Delicate Garments Ltd

10th May 2014

Observations

Typical floor loading plan

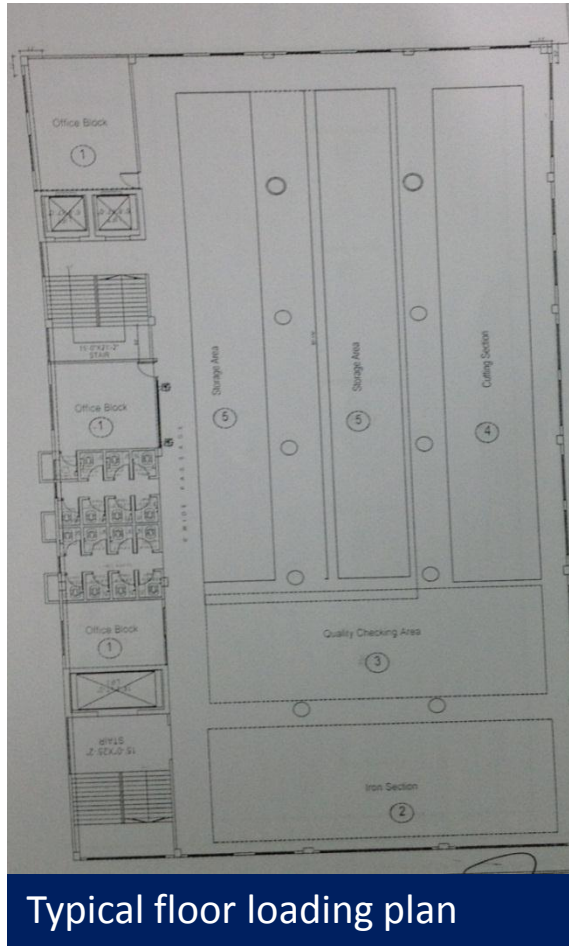
Allowable loading shown on Loading Plans is very high.

An allowable imposed load of 250 psf (12kPa) shown in all areas of all floors.

Existing loads are very significantly lighter.

- Factory Engineer to revise allowable loading document to include maximum allowable load of 5kPa and check capacity of slabs and beams under this loading.

Extent of cracking

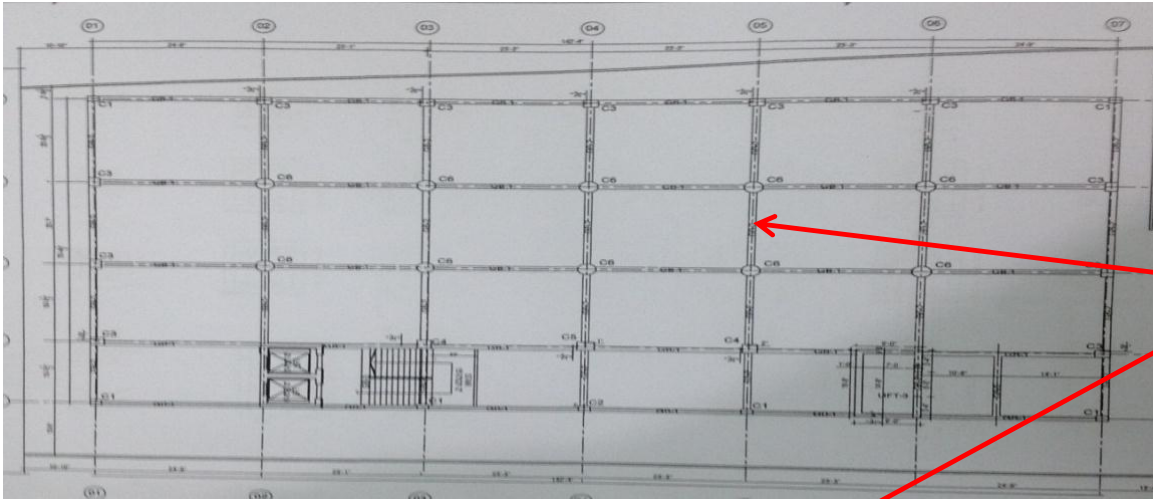
Ground Floor Cracking:

Cracks along line of ground beams may be the result of settlement of the filling under the floor slab. Cracking is visible in areas without floor finish.

- Factory Engineer to monitor settlement of the ground floor slab and note if any settlement occurs in foundations to the main structural elements.
